# FORD PERFORMANCE

## **Technical Service Bulletin – 20**

### **Master Cylinder Fitting Revision**

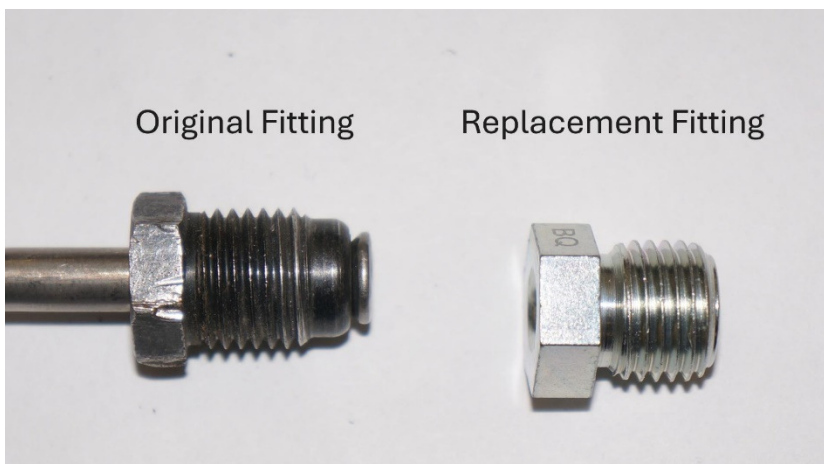
Issue: An improper fitting was used during build of cars 1-40

- The improper fitting can be identified in the photo below.

- Replace fittings (2 places) with the Ford Performance part number 9183-MTN.
